UNITED STATES PATENT AND TRADEMARK OFFICE

Office Action Summary

10/600,379

TAYLOR, STEVE B.

Patent 5697320 (see marked-up figures below).

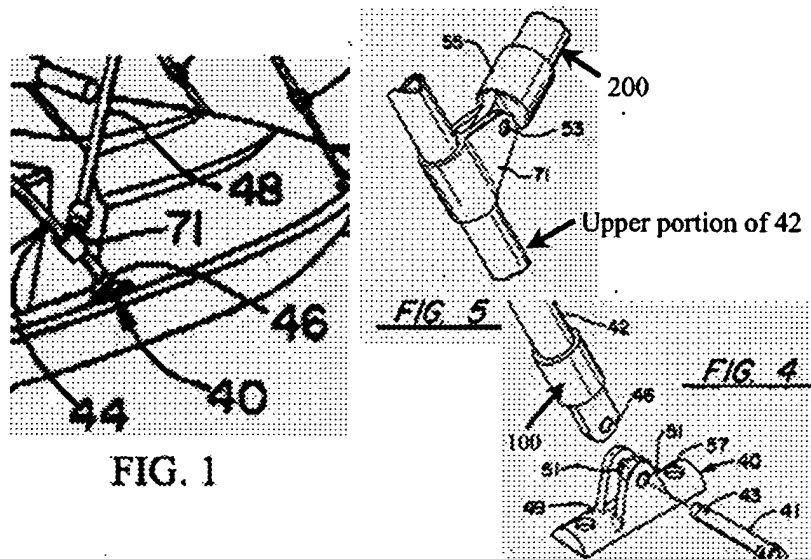
Claims 1-3 are rejected under 35 U.S.C. 102(b) as being anticipated by Murray U.S.

Claim 1. Murray discloses (figs. 1, 4, 5) a variably positionable coupler mountable on a curved surface, comprising: a base (40) formed with an upper side and a lower side, wherein the lower side is a substantially flat planar surface; means (57) for mounting the base on the curved surface (curved surface of the watercraft as seen in figure 1); a tub (100) adjustably connectable to the base; a plug [42 (including upper portion of 42) and 71] repositionably attachable to the tub; a neck (55) rotatably insertable in the plug [42 (including upper portion of 42) and 71], wherein the neck is formed for securing a shaft (200) to the neck; and a clevis mechanism (clevis

connection between 55 and 71) slidably and demountably engageable with the plug and the neck. (Note that while the Murray curved surface does not curve at its point of contact with element 40, it does curve elsewhere and is thus a curved surface within the broadest reasonable interpretation of the claim language).

Claim 2. Murray discloses opposing yokes (tab portions of 40 receiving 41) monolithically extending at substantially right angles from the upper side of the base.

Claim 3. Murray discloses one or more bores (51) formed in the base with a proximal end and a distal end, and further wherein the one or more bores are shaped for removable engagement with a bolt (41). The word "bolt" is taken by the Examiner to mean, "a metal rod or pin for fastening objects together" in accordance with Merriam-Webster's Collegiate Dictionary Tenth Edition.

The Applicant argues that element (55) of Murray cannot be the neck since the Examiner has already identified element (55) as being tub (100). This is not persuasive. The marked-up drawings clearly show that the Murray tub (100) and Murray neck (55) are two separate elements.

The Applicant argues that the Murray neck (55) is not insertable in the plug. This is not persuasive since the marked-up figures clearly show a plug [42 (including upper portion of 42)

and 71] repositionably attached to the tub (100); a neck (55) rotatably inserted in the plug [42 (including upper portion of 42) and 71].
